**IEEE 802.11**  
**Wireless Access Method and Physical Layer Specifications**

**Title:** Changes Required on Draft 3.1 to Support MultiRate

This paper, which replaces documents IEEE P802.11-96/71 and IEEE P802.11-96/79 together with document IEEE P802.11-96/71, reflects the changes required to the Draft Standard (D3.16) in order to support MultiRate as proposed by the MultiRate Working SubGroup in the March Meeting at La Jolla.

Adopt the text changes proposed in this paper for inclusion in P802.11/D4.0

Figure 5, IFS Relationships

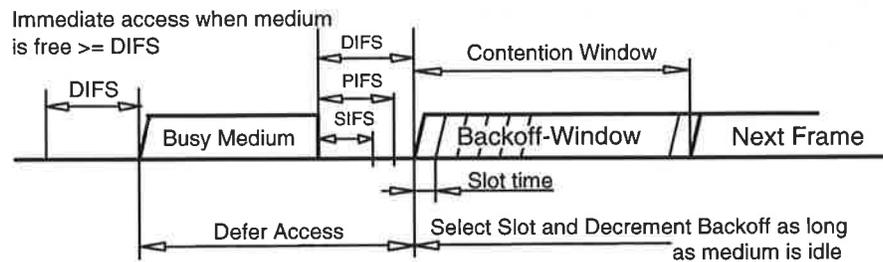
The time interval between frames is called the inter-frame space. A STA shall determine that the medium is free through the use of the carrier sense function for the interval specified. ~~Three~~<sup>Four</sup> different IFSs are defined so as to provide of priority levels for access to the wireless media. The following ~~three~~<sup>four</sup> different IFSs are defined:

- a) SIFS                **Short Interframe Space**
- b) PIFS              **Point Coordination Function (PCF) Interframe Space**
- c) DIFS              **Distributed Coordination Function (DCF) Interframe Space**
- d) EIFS              **Extended Interframe Space**

The different IFSs are independent of the station bit rate. The IFS timings are defined as time gaps on the medium, and are a fixed per each PHY (even in multi-rate capable PHYs). PHY MIB parameters are specify IFS values.

**Figure 9, DCF Timing Relationships**

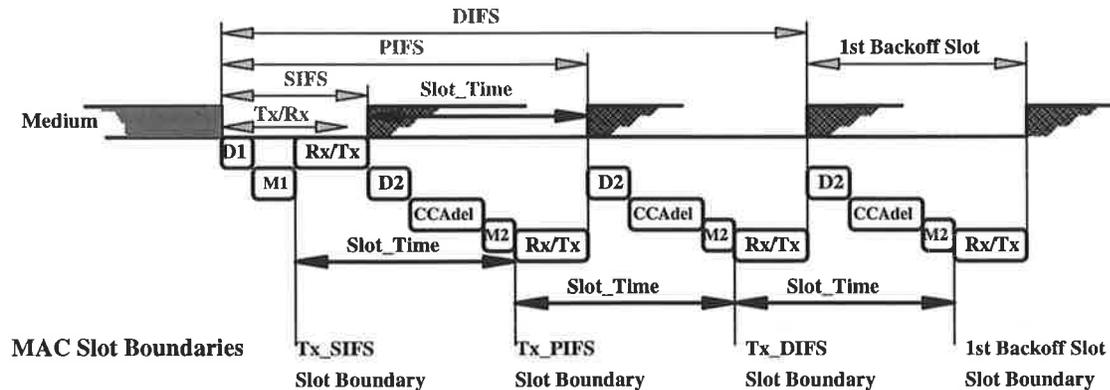
The EIFS is derived from the SIFS and the DIFS and the length of time it takes to transmit an Acknowledge control frame at 1 Mbps by the following equation:

$$EIFS = aSIFS\_Time + aACK\_Time + aDIFS\_Time$$
